**SUPPLEMENT TO FINAL  
ENVIRONMENTAL IMPACT REPORT**

**FOR THE  
ARANTINE HILLS SPECIFIC PLAN AMENDMENT**

**CITY OF CORONA, CALIFORNIA**

May 9, 2016

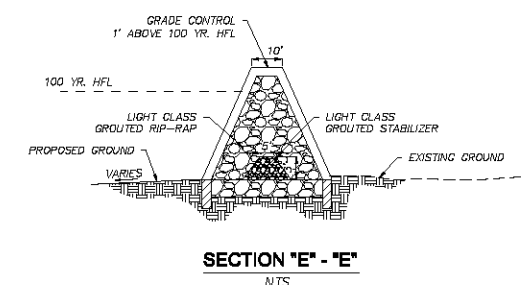
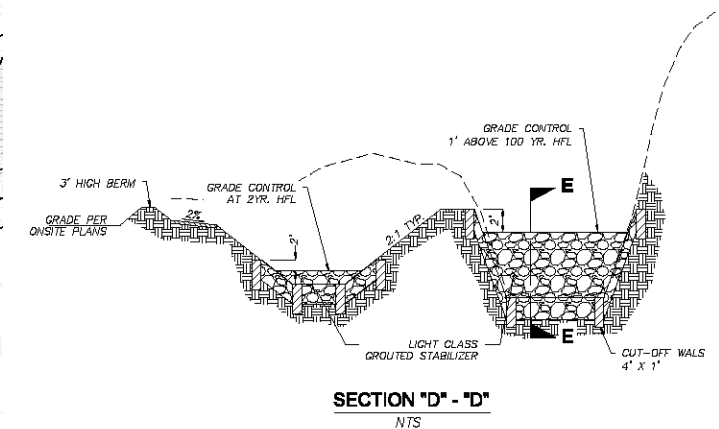
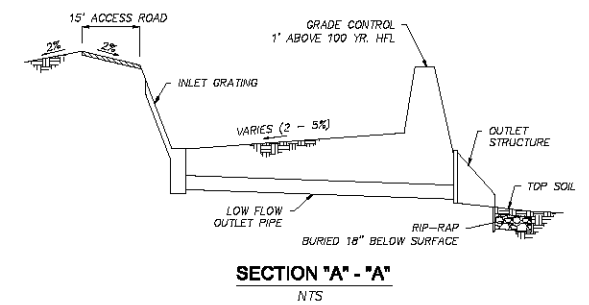
indicates the final channel widths in relation to buffers, dikes, and the adjacent development, nor the proposed locations of the two detention basins, restored channel segments, grade controls crossing the channel, or riprap along the channel sides. Further, "Appendix C-1 Floodplain Analysis, Bedford Wash at Arantine Hills Figure 2- Aerial Photograph," exhibits a Project boundary line extending only partway across Bedford Canyon Wash in the higher elevations of the Project. It appears the Project proponent does not control areas upstream of the Project boundary where an effective detention basin would be constructed. Please verify that the Project would have access to all of the area within BCW and upstream of the Project in order to sufficiently implement any of the three options discussed.

**Response to Comment R-4.10:** Graphics showing all three options are included at the end of this response to Letter R-4. The upstream detention basin is located outside of the project boundaries. However, the Applicant is in the process of obtaining an easement from the adjoining property owner to construct and maintain the detention basin. An area within Bedford Canyon Wash near the upstream portion of the project site is also not under control of the Applicant. This ownership affects only Option 3 and the restoration of Bedford Wash. In this area, the restoration of Bedford Wash avoids the parcel not under control of the Applicant, as shown on the graphics provided below. The Applicant is in the process of trying to obtain rights to that parcel and, if successful, would expand the restoration of Bedford Wash to include this area.

**Note:** These comments result in the need to revise terminology in the description of Option 3. Any reference to "bypass channel" will be replaced with "restored wash" in the description of Option 3.
